Our Ref: 19355

18 September 2019

**RE: 115-117 COWPASTURE ROAD, WETHERILL PARK (DA 428.1/2018)
RESPONSE TO COUNCIL COMMENTS – SIGHT DISTANCE ASSESSMENT**

Figure 4: Sight Distance Assessment – Right-side Approach (83m at a height of 1.15m)

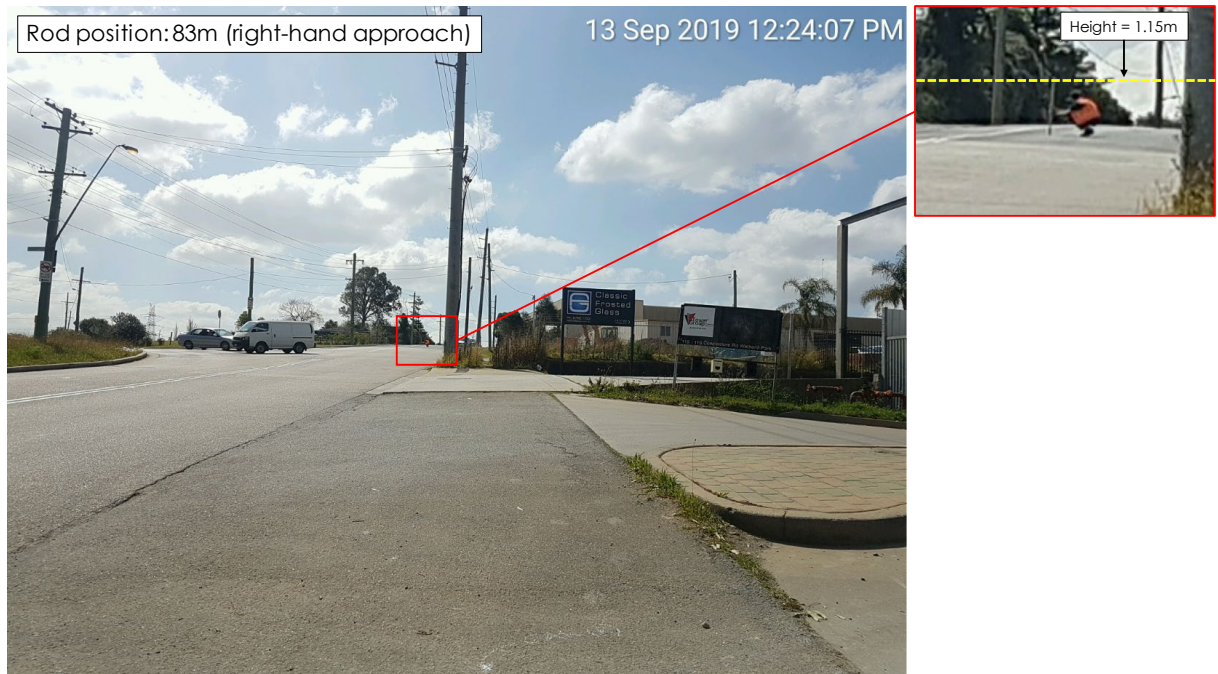
- *“A site investigation by Council's Traffic Engineers has revealed that the sight distance for motorists exiting from the development is restricted by the crest, which is situated on Cowpasture Road, north of the subject site. Access driveways shall be located where there is adequate sight distance available for motorists exiting the site to see oncoming traffic. Sight distance assessment shall be undertaken to ensure compliance with the requirement of AS/NZ 2890.1:2004. The applicant shall provide a response.”*

It should be noted that the existing power pole on the right-side of the driveway (looking north) on Cowpasture Road restricts sight distance to the edge of Cowpasture Road. However, a sight distance of 83m is provided to the centre of the road, as shown in Figure 4. Therefore, the sight distance requirement at this point is considered to satisfactorily comply with AS2890.1:2004 design requirements.

On 13 September 2019, TTPP carried out a sight distance assessment during daylight hours. Based on this, TTPP confirms that a sight distance of at least 83m is provided on either side at the existing access onto Cowpasture Road in accordance with AS2890.1:2004 design requirements. The sight distance diagram is shown in Attachment One.

On this basis, TTPP confirms that the existing vehicle access satisfactorily complies with AS2890.1:2004 sight distance requirements.
